BROOKHAVEN NATIONAL LABORATORY
ASSOCIATED UNIVERSITIES, INC.

July 25, 1983

This letter report describes the work performed by BNL on the review and evaluation of the buried fuel tanks utilization the Diablo Canyon Plant. The work was completed in May of 1983 and the results were presented in a public meeting held in Bethesda, MD on June 17, 1983.

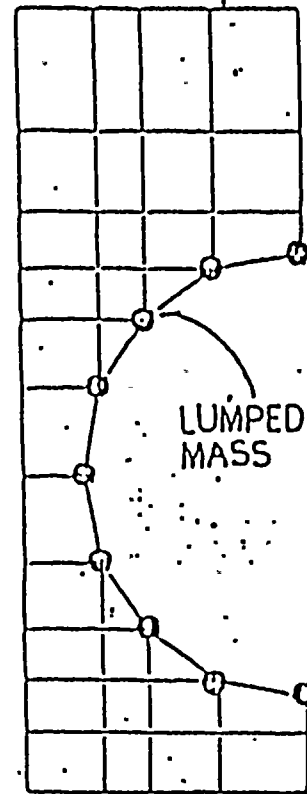
The objective for reviewing the 1978 work was to identify a variety of data, i.e., soil properties, damping values, etc., needed for the subsequent BNL evaluations. The dynamic response of the tanks due to the Newmark-Hosgri event was reviewed on the basis of the 1982 re-analysis results. The FLUSH model of the soil-tank system used by Harding and Lawson in the 1982 re-analysis is shown in Fig. 1a. A lumped mass model was constructed (see Fig. 1b) with the fluid modeled as lumped masses rather than finite elements. The objective for developing this model was to obtain a quantitative appreciation of the effect of the fluid on the seismic response of the tank. Seismic responses due to the Newmark-Hosgri earthquake applied in the horizontal direction using the lumped mass model were obtained with the FLUSH computer program. The results of this analysis are shown in Table 1 together with the corresponding results from the Harding and Lawson 1982 re-analysis. By inspection of the results shown in Table 1, it can be concluded that the results obtained by Harding and Lawson differ significantly from the corresponding results obtained by BNL via the lumped mass model. It was felt that this difference cannot be justified on the basis of the sloshing effect alone which is not included in the lumped model. The sloshing effect would usually be expected to alter the response by 10 to 20%. Sloshing frequencies were calculated and found to be very low, i.e., 0.1 Hz. As such, they should not have important effects on the response of the tank. In view of this, BNL concluded that the significant differences between the Harding and Lawson model and the lumped model constructed by BNL were due to the fluid elements used in the Harding and Lawson model.

In reviewing the computer printout from the FLUSH code, it was observed that the Poisson's ratio value used for the fluid elements was equal to 0.4999, whereas, the instructions in the FLUSH manual clearly state that this value must be below 0.49. Thus, initially it was suspected that this was the problem. In reflecting upon this problem and the flexural ring modes that occur in such a structure, BNL came to the conclusion that such modes could not exist in the Harding and Lawson model because of the inappropriate fluid modeling. Specifically, as a result of the finite element discretization used by Harding and Lawson, the fluid is not allowed to perform its natural motion. Results from a finer grid indeed, proved this BNL position.

Fig. 2

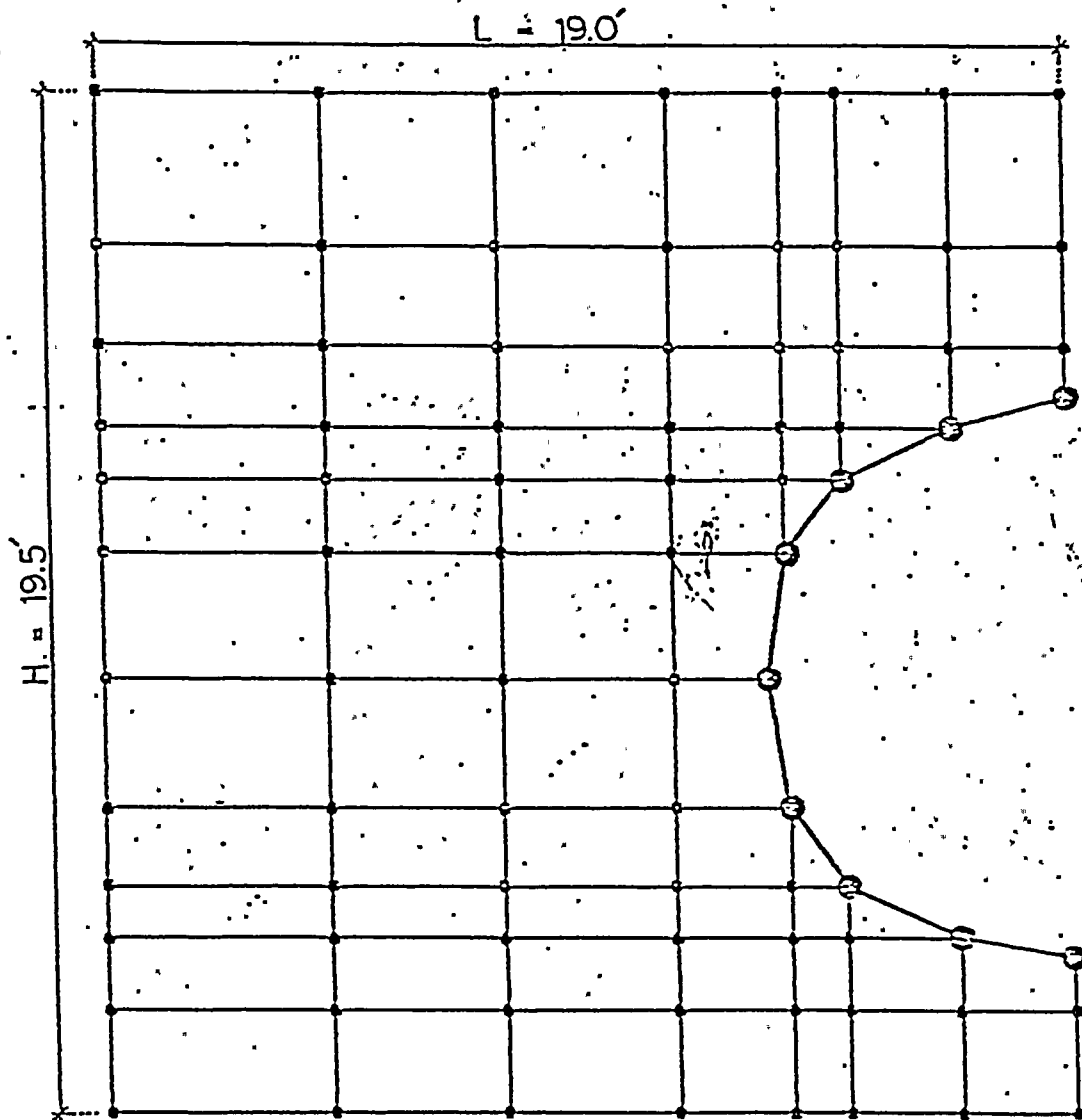
The FLUSH model, shown in Fig. 2, was used for the response evaluation of the soil-tank system normal to the tank axis (transverse response). Inside the trench, it was decided to construct the model in a similar fashion to the one used by Harding and Lawson (Z-Z section) for the 1982 re-analysis. The major difference, however, was that the mass of the oil was lumped at the walls of the tank. This approach although, somewhat conservative, was found to be more appropriate than that of the fluid element idealization employed in the 1982 re-analysis model by Harding and Lawson. Furthermore, in the BNL model, the transmitting boundaries were moved further away from the tank walls. This was done to avoid possible reflections at the boundaries.

Fig. 3

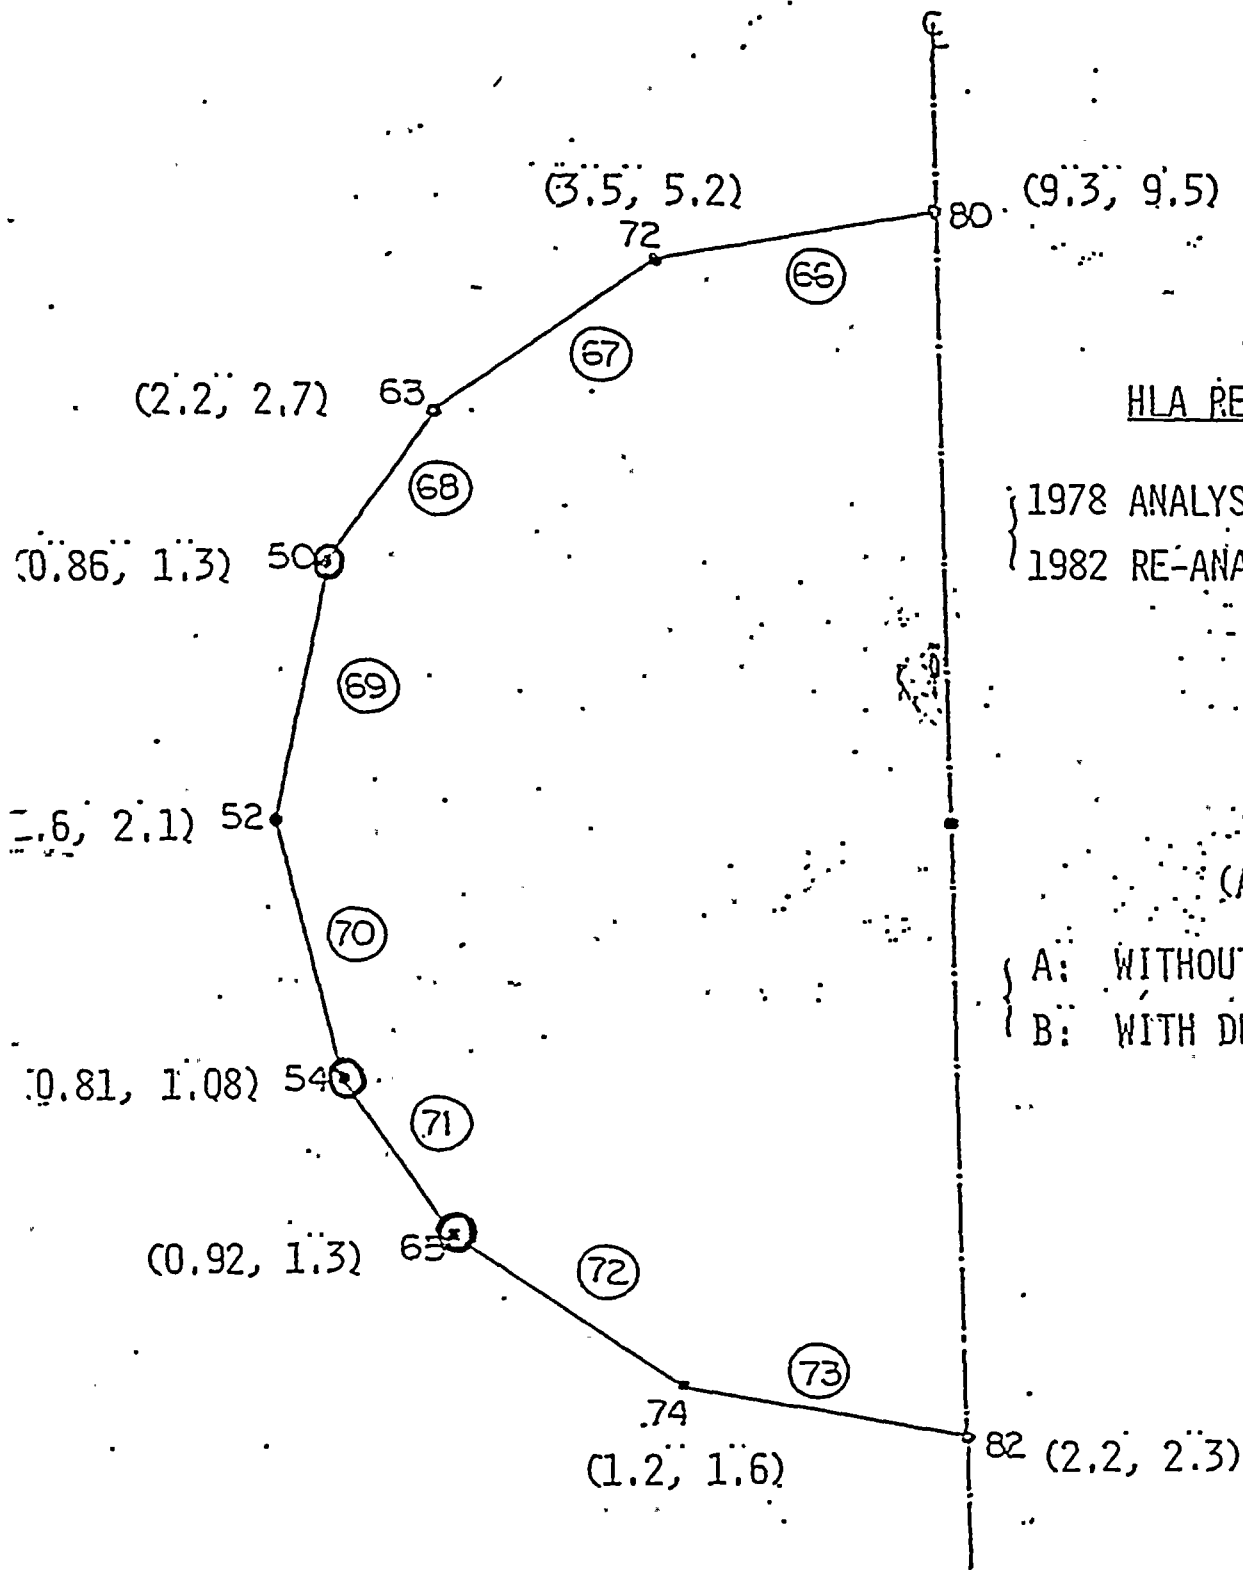
seismic stresses obtained by BNL were then combined with the static stresses given by Harding and Lawson in their 1982 static re-analysis. Based on the total stresses (i.e., static dynamic) safety factors were computed. In evaluating the safety factors the same approach as that used in the 1982 re-analysis was employed. These safety factors are depicted in Fig. 3.

Fig. 4

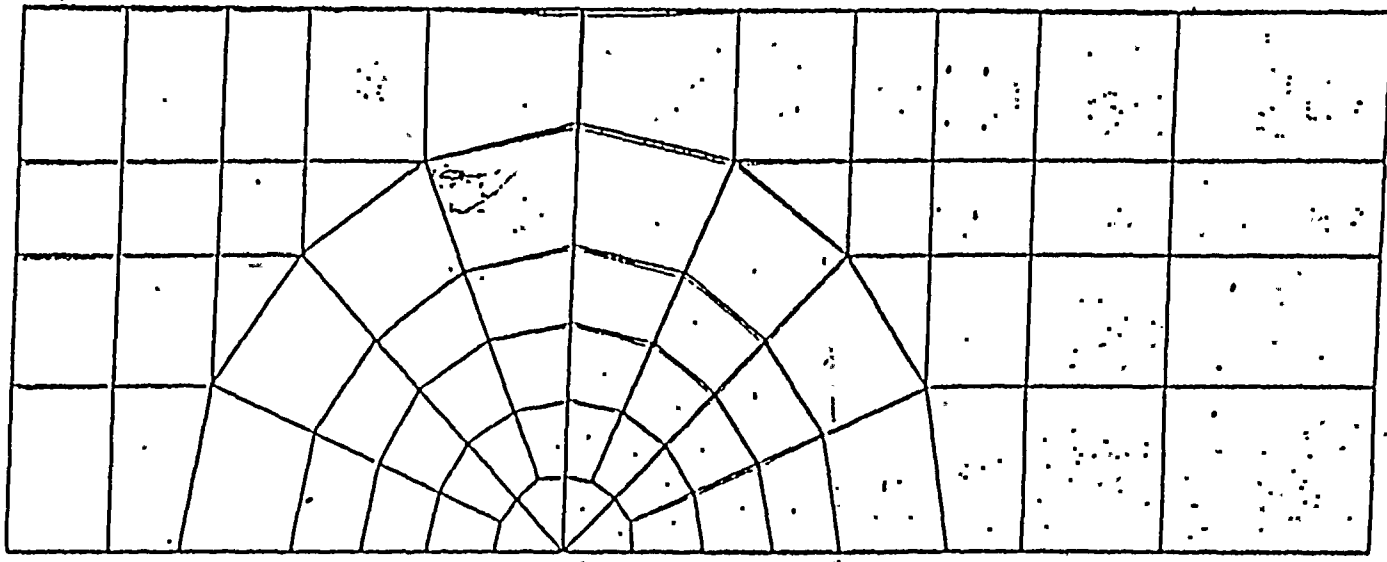
The BNL refined FLUSH model is shown in Fig. 4. This model was essentially constructed from the Harding and Lawson 1982 re-analysis model. The finite element grid of the fluid, however, was as can be seen substantially, refined. Two types of soil properties were assigned to the model. These are the ZZ and YY section properties.

Soil structure interaction evaluations were performed in the horizontal direction only. These were felt to be sufficient to prove the BNL contention regarding the modeling problem associated with the Harding and Lawson 1982 analysis model. Two sets of runs were made using the ZZ and YY section soil properties. Results are summarized in Tables 2, 3 and 4. From these it is clear that the refined model results are closer to the corresponding lumped model results. It is also fairly clear that the Harding and Lawson 1982 model differs significantly from both the refined and the lumped model. Furthermore, the responses from the YY model indicated that this model is more criti-

ical than the ZZ model. From very limited investigation, it also seems that even higher response would result if YY section properties were to be used together with deconvolution. Finally, initial computer runs made with partially filled tanks also resulted in higher response values. In these initial studies, the partially filled tank was simulated by using the model described in Fig. 4 and by assigning very low stiffness values to the top fluid layer so that it approximated a 90% filled case. For such a case, the bending, particularly, at the top portion of the tank increases. The reason for this is that due to the upward motion of the fluid inside the tank there is less fluid resistance to the tank deformations.
